FIRE SAFETY INSPECTION REPORT

Occupant Name:	Heron Pond	Inspection Date:	1/19/2023
Address:	8471 Southwest 5 Street	Inspected By:	Victor Santos
Suite:	Bldg. - #13	Property Use Type:	Multifamily dwelling
Occupant Number:		InspectionType:	Annual Fire Alarm (FAS), Annual Fire and Life Safety Inspection
Occ. Sq. Ft.:	20000	Number of AEDs:	0

1.1 - 10.1.4.1.

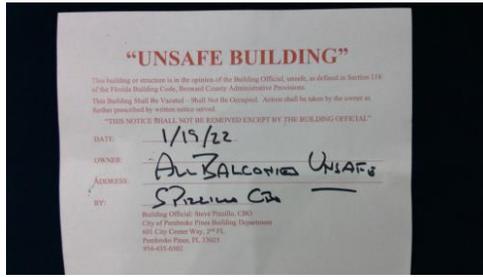
Deficiency		FL NFPA 01 2018 Chapter 10 General Safety Requirements	10.1.4.1 - Excerpt: Where structural elements have visible damage, the AHJ shall... (see photo 1.1)
-------------------	--	--	---

Inspector Comments: ***The noted structural damages have been referred to the City's Building Official and Structural Chief for evaluation of possible unsafe conditions. A site visit with structural inspectors and the Building Official to demonstrate areas of concern was conducted. Following the site visit, an structural engineer was consulted and in conjunction with the Building Official, deemed each patio/balcony area unsafe. The Building Official instructed Xochitl Alvarez, the property manager, to produce an analysis and proposal completed by a structural engineer for conditions and repairs within 48 hours. Each building and unit had an "Unsafe Building" notice posted on the front door as well as verbally communicated with residents who were home at the time. Residents were instructed that due to the unsafe conditions, they are to remain clear of the patio/balcony area until further notice is given.***
